CITY OF PENSACOLA, FLORIDA
ADDENDUM #4

Fricker Resource Center Renovation

Bid No. 26-021

ADDENDUM NO. 4

ITEM 4: **Sheet E0.11**

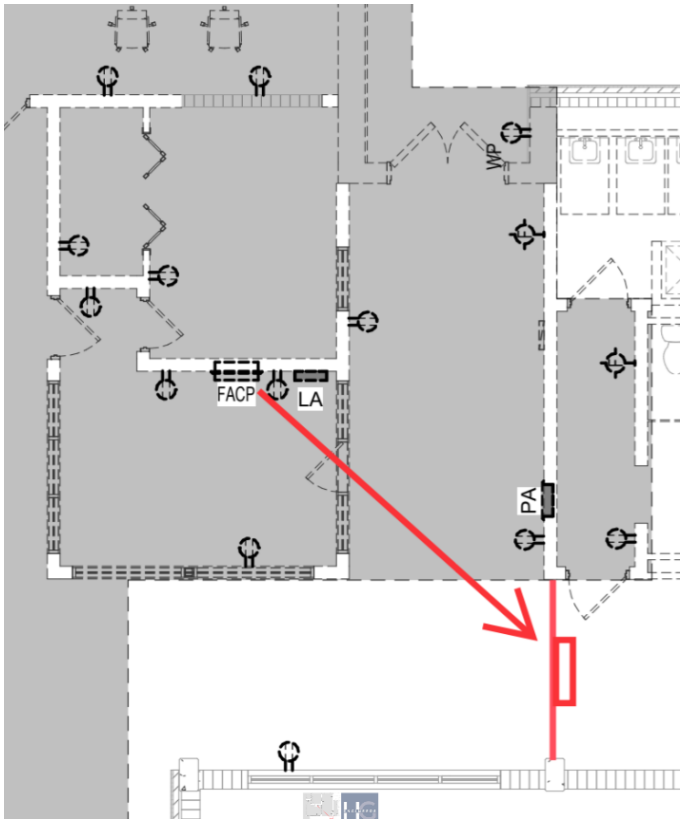
The existing fire alarm control panel shall be relocated to the temporary construction wall during phase 1A. All existing fire alarm circuits serving the portion of the building remaining active shall be relocated to the new panel location. Provide dedicated 120V 20A circuit to the new panel location from existing panel SR. The fire alarm system shall remain active during construction for the occupied part of the building.
